**From:** Scala, Mary Joy  
**Sent:** Wednesday, October 25, 2017 4:32 PM  
**To:** 'Michael Williams'  
**Subject:** BAR Action - 222 E Main Street - October 17, 2017

**RE: Certificate of Appropriateness Application**  
BAR 17-10-04  
222 East Main Street  
Tax Parcel 280037A00  
Williams Pentagram Corps, Owner/ Michael R. Williams, Applicant  
Window Replacement

**CITY OF CHARLOTTESVILLE  
BOARD OF ARCHITECTURAL REVIEW  
STAFF REPORT  
October 17, 2017**

Window Replacement

## ATTACHMENT C (G&W options)

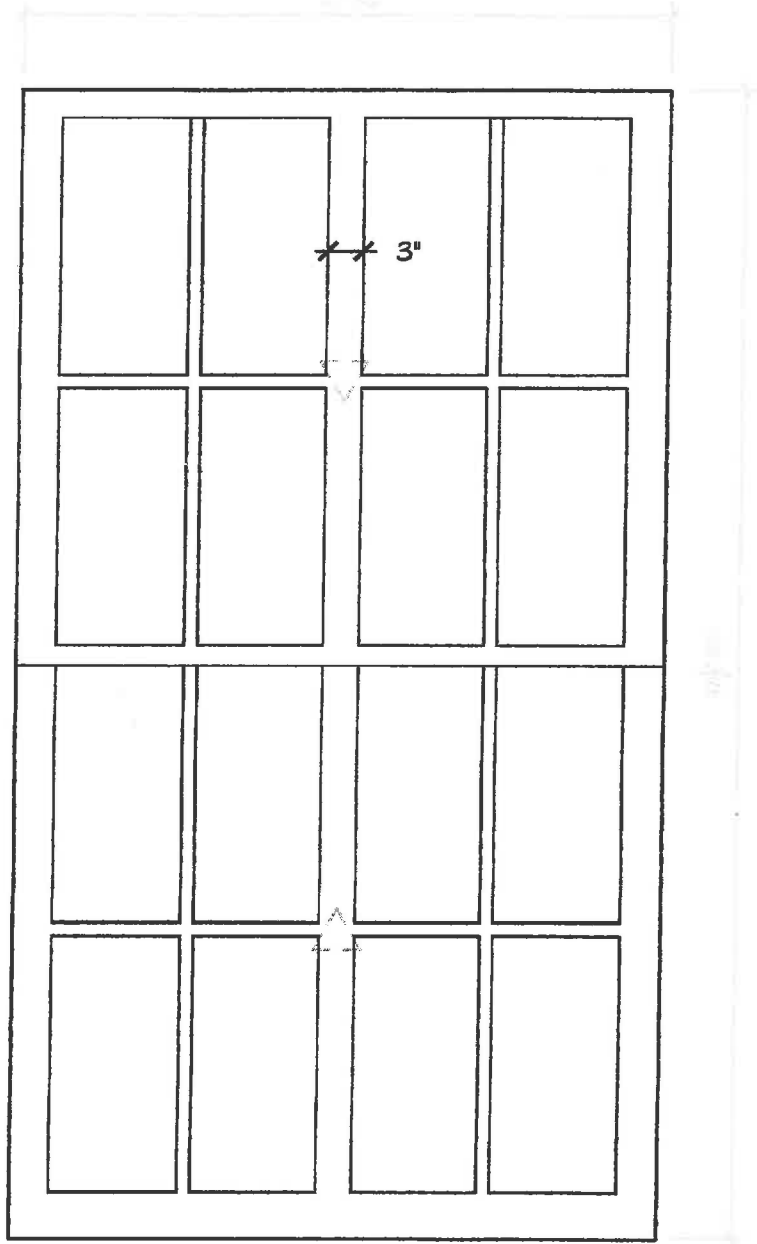
**Schwarz moved: Having considered the standards set forth within the City Code, including City Design Guidelines for Rehabilitation, I move to find that the proposed window replacement satisfies the BAR's criteria and is compatible with this property and other properties in the Downtown ADC district, and that the BAR approves the application for the aluminum clad window with the standard size central muntin, we just ask that the applicant confirms the size of the smaller muntins and what the best match is to that. Sarafin seconded. Approved (7-0).**

In staff opinion, either a wood window or an aluminum clad wood window would be appropriate. The applicant makes a practical argument for the clad version (maintenance costs and previously approved windows are clad). The BAR needs to weigh in on the importance of replicating the 3" center rail versus a less expensive 2-1/2" version.
